# UNITED STATES PATENT AND TRADEMARK OFFICE

APPLICATION NO.	FILING DATE	FIRST NAMED INVENTOR	ATTORNEY DOCKET NO.	CONFIRMATION NO.
10/735,664	12/16/2003	Vladimir M. Kabakov		2852

<b>Office Action Summary</b>	Application No. 10/735,664	Applicant(s) KABAKOV, VLADIMIR M.	
	Examiner Sherman D. Basinger	Art Unit 3617

## **DETAILED ACTION**

Fig. 4.

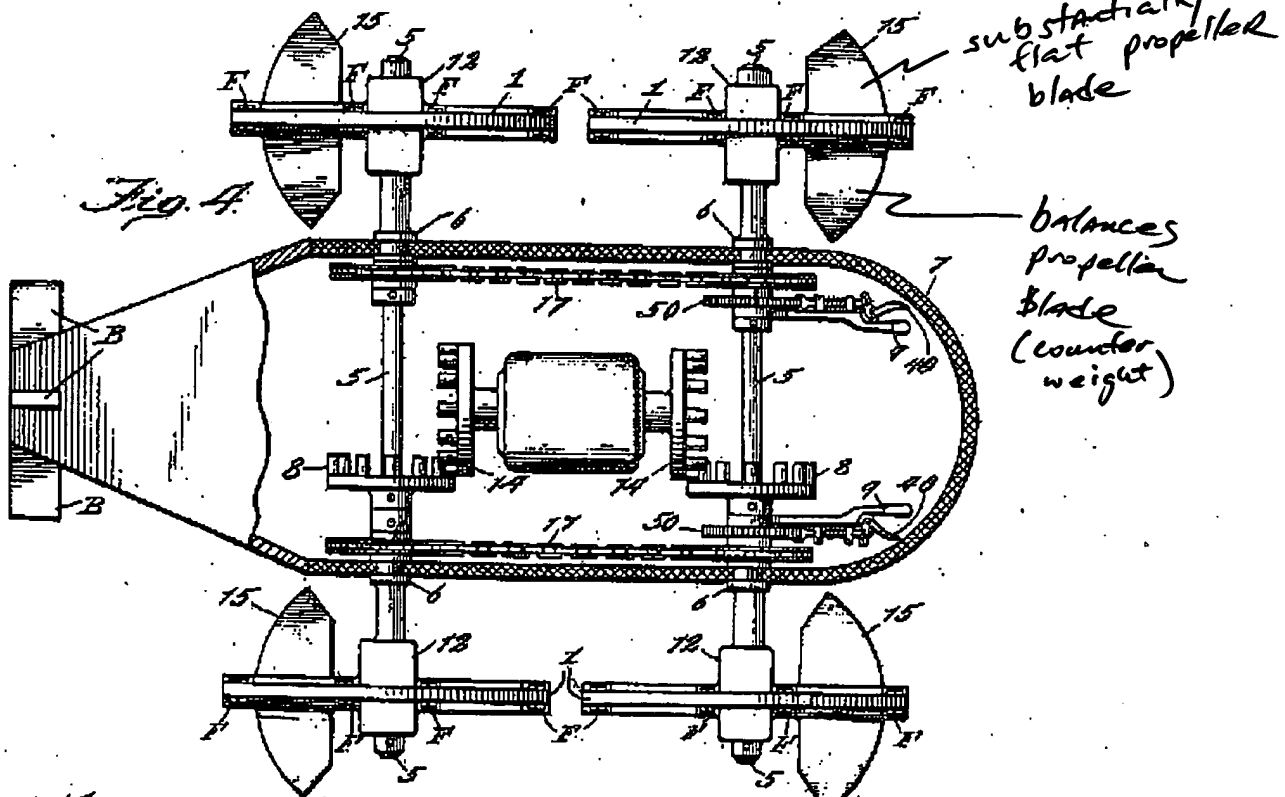
axes (note the attached copy of figure 4 of Roney which has been marked to show what is considered to be the flat propeller blade and what is considered to be balance or counterweight for the blade so as to balance the blade on the axes 2,2.

Roney further discloses disposing said at least one substantially flat propeller

Blade 15 substantially in a plane of the rotation around one of said at least two radial axes in that such a plane passes through the thickness of the blade.
